September 7, 1984

HOPE CREEK GENERATING STATION
DOCKET NO. 50-354
DRAFT SAFETY EVALUATION REPORT
OPEN ITEM STATUS

Attachment 1 is a current list which provides a status of the open items identified in Section 1.7 of the Draft Safety Evaluation Report (SER). Items identified as "complete" are those for which PSE&G has provided responses and no confirmation of status has been received from the staff. We will consider these items closed unless notified otherwise. In order to permit timely resolution of items identified as "complete" which may not be resolved to the staff's satisfaction, please provide a specific description of the issue which remains to be resolved.

HOPE CREEK GENERATING STATION FINAL SAFETY ANALYSIS REPORT	
SAFE LOAD PATH DRAWING (EL. 201) REACTOR BUILDING POLAR CRANE 10H200	
FIGURE 9.1-32 SHEET 11 OF 12	AMENDMENT 0, 10/84

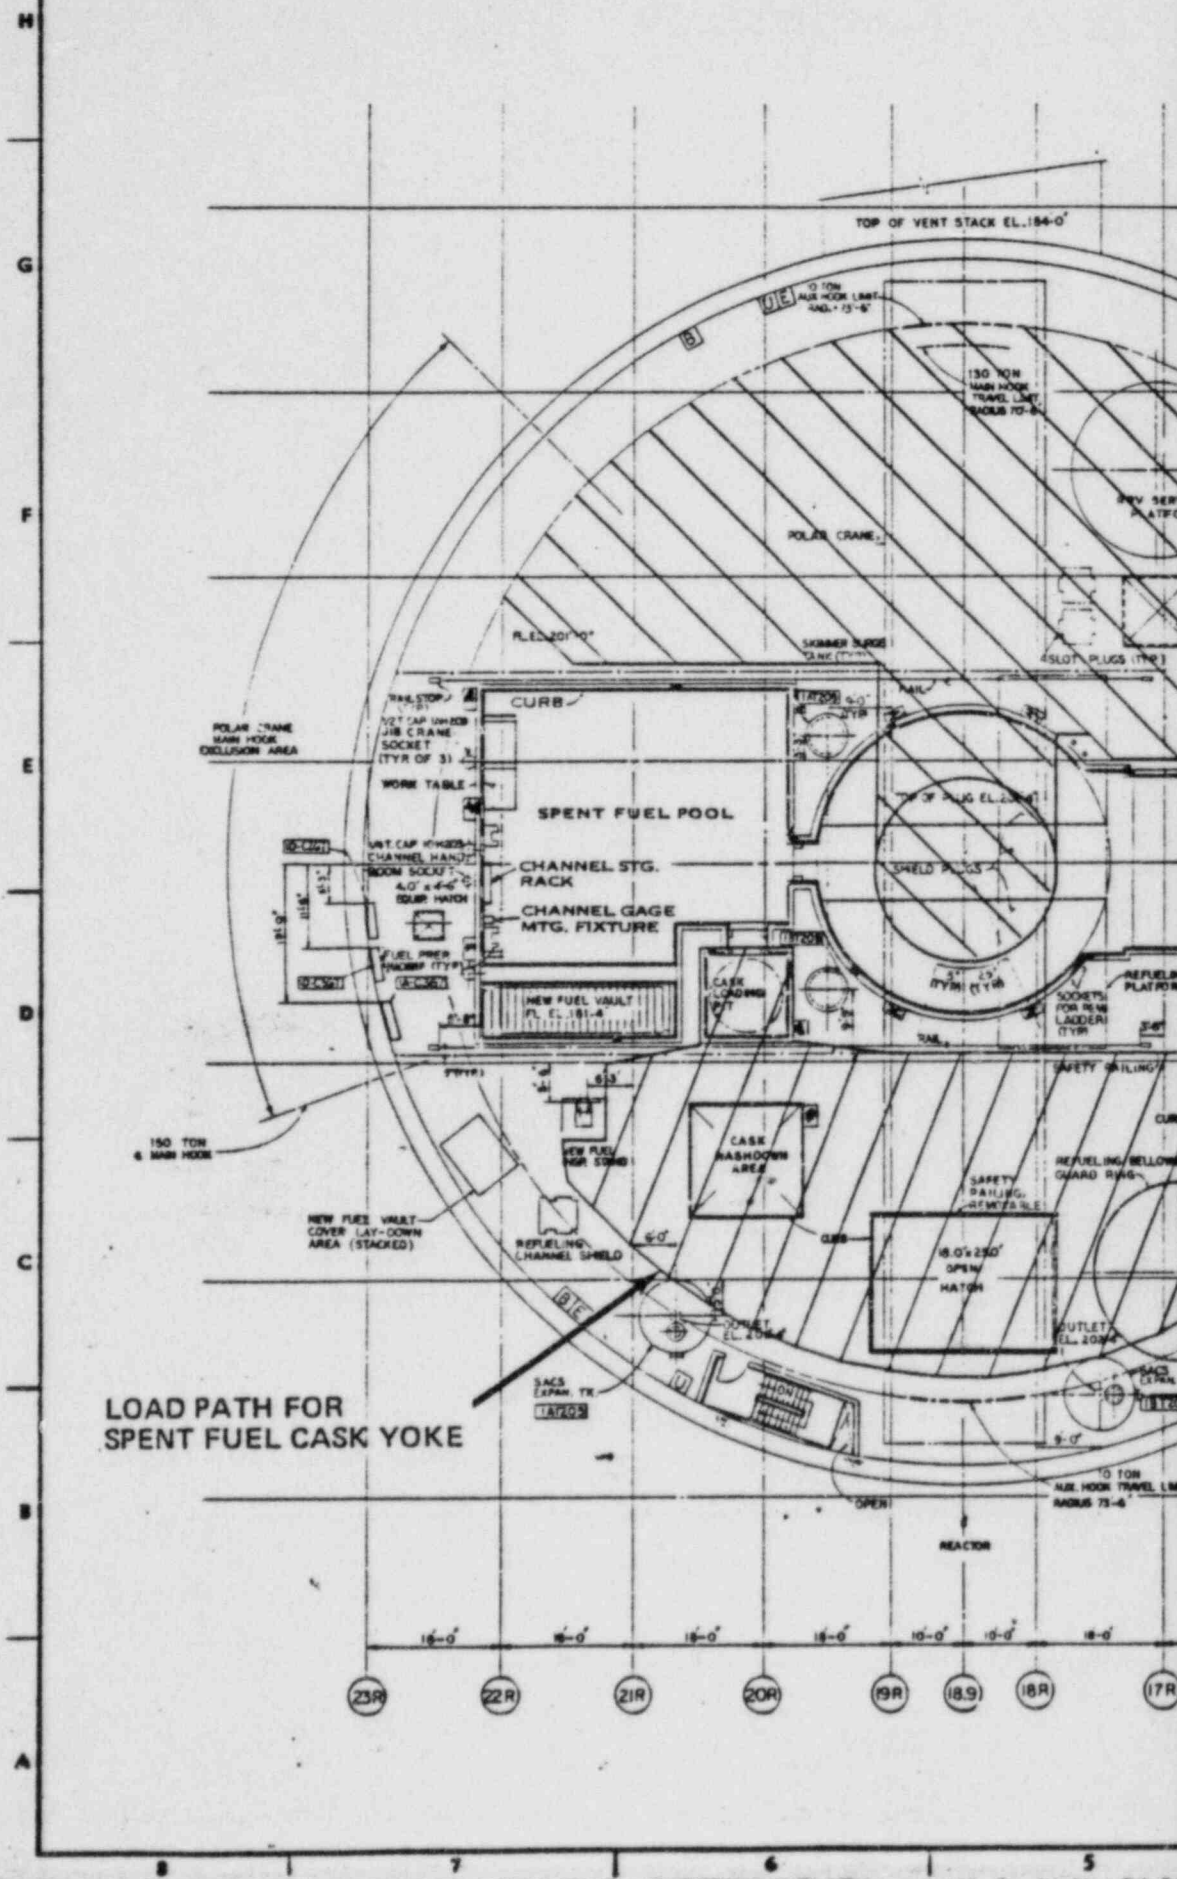
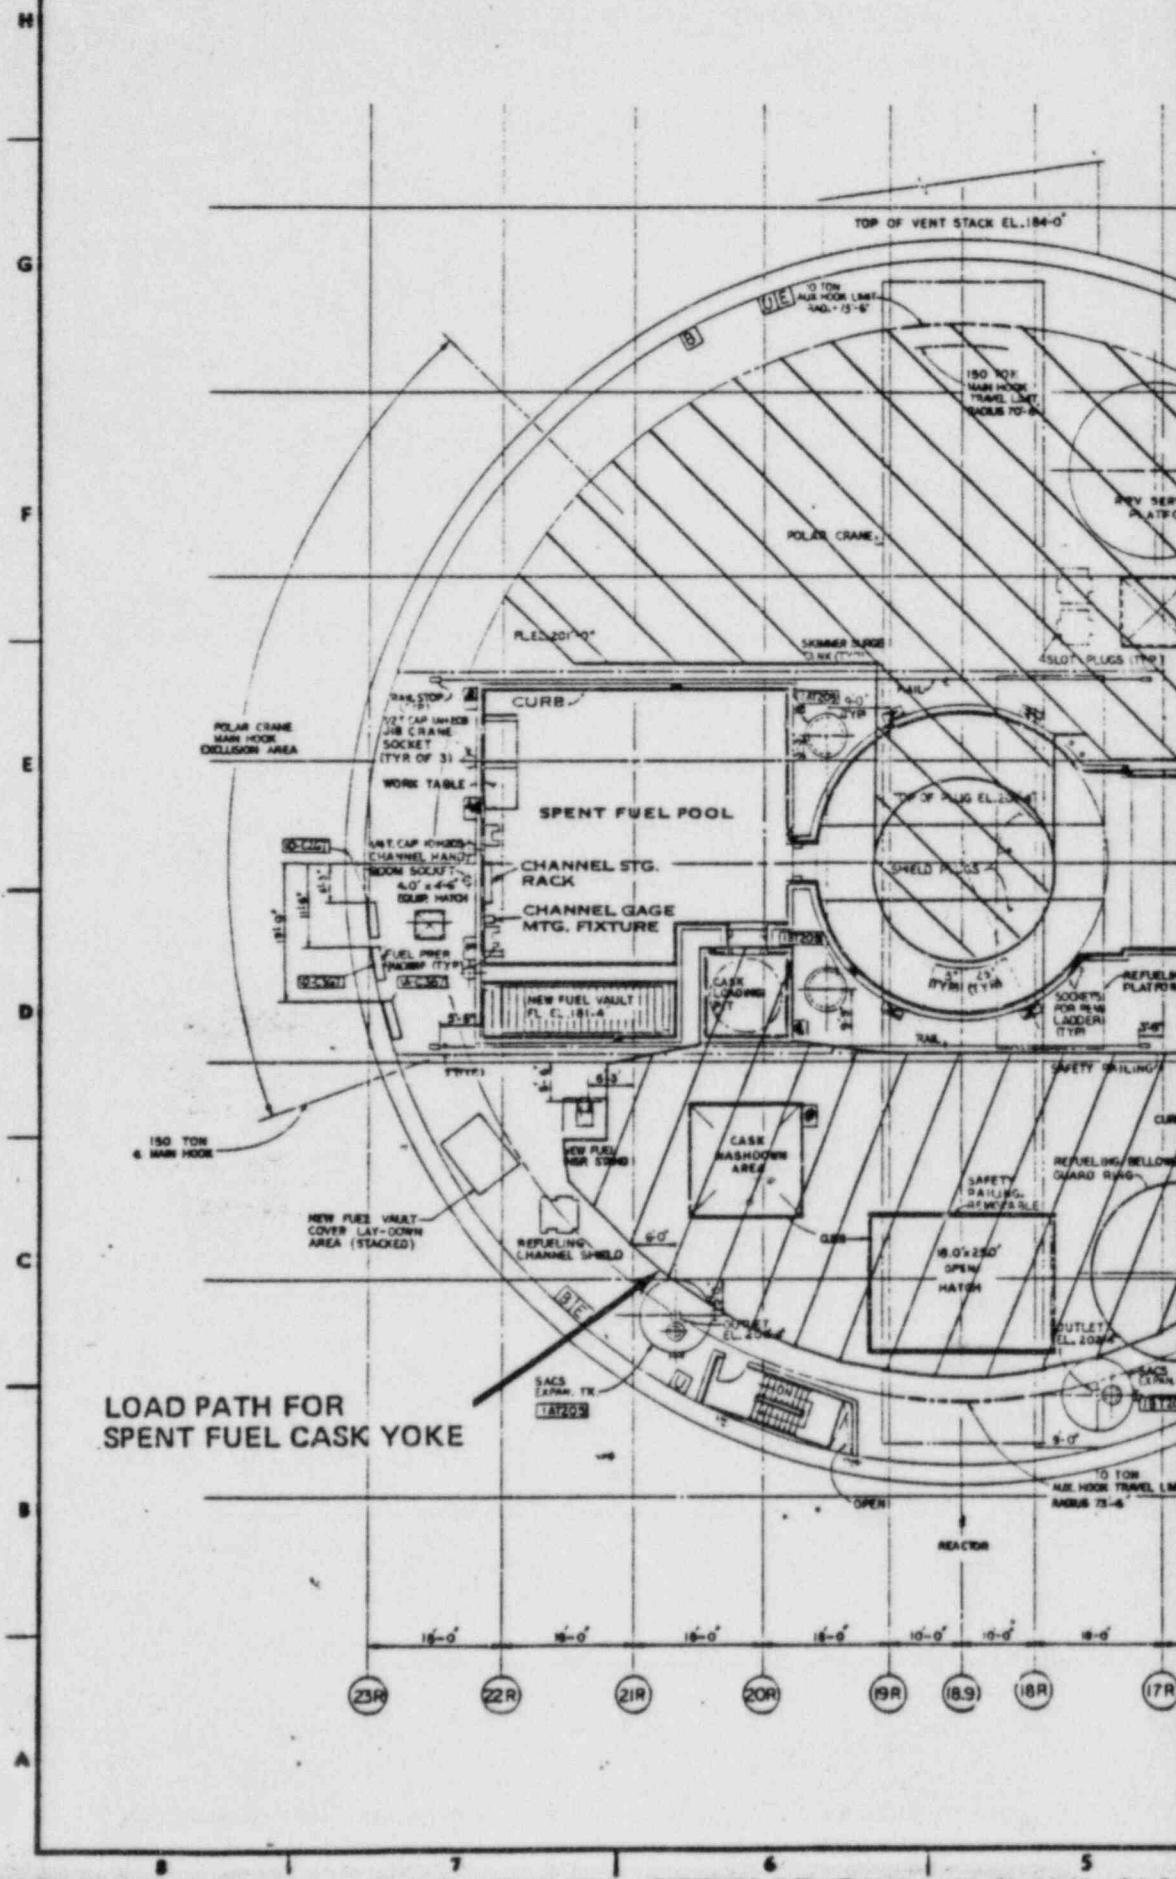
Safe load paths for three additional polar crane heavy loads that are listed in Table 9.1-12, but not mentioned in Item B.3.a of DSER, Appendix A, have been added to Figure 9.1-32. The main hoist load block, auxiliary hoist load block, and spent fuel cask yoke are shown on new Sheets 9, 10, and 11, respectively.

FIGURE 9.1-32
-SHEET 12 OF 12

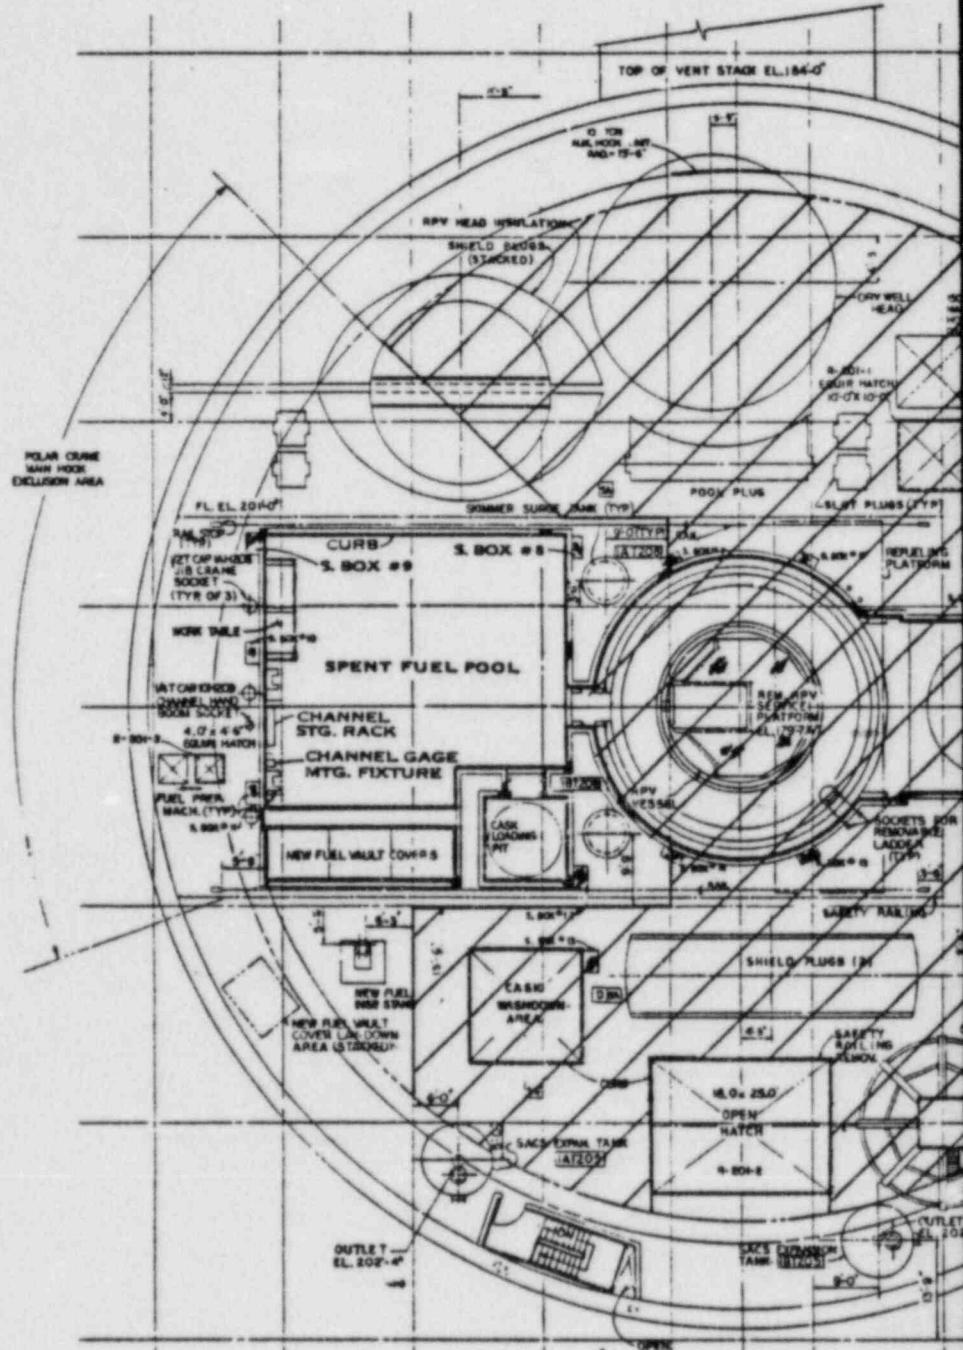
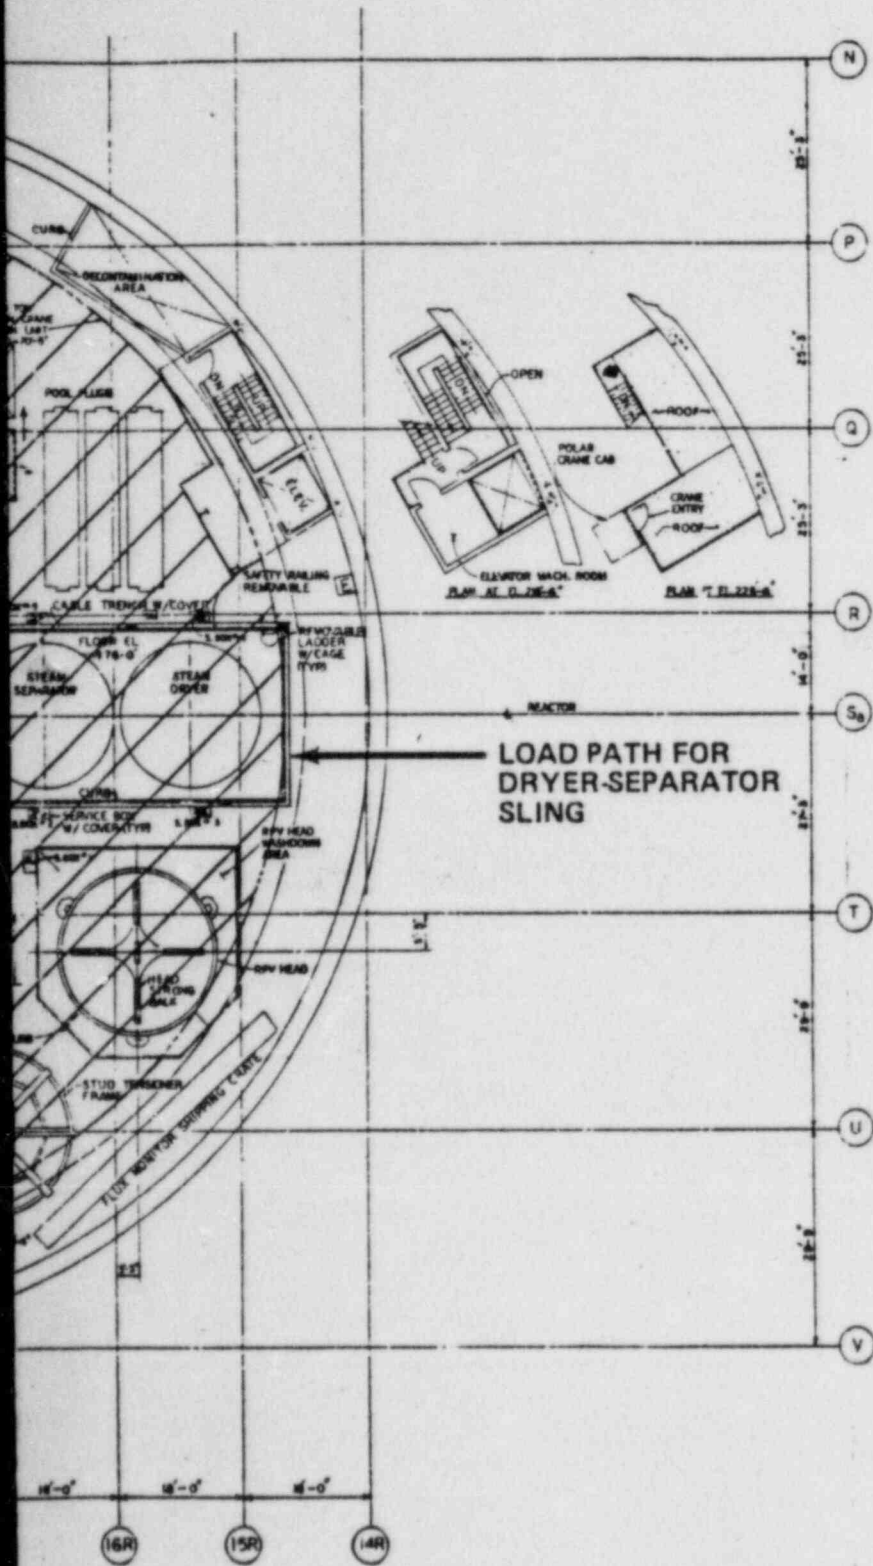
The dryer-separator sling has been added to Table 9.1-12, and the load path is shown on new Sheet 12. The spent fuel rack modules and the fuel rack lifting fixture have been added to Table 9.1-12, and the load paths are shown on revised Sheet 4 of Figure 9.1-32. The reactor well shield plug sling and the dryer-separator pool plug grapple have been added to Table 9.1-12, and the load paths are shown on new Sheet 9 of Figure 9.1-32.
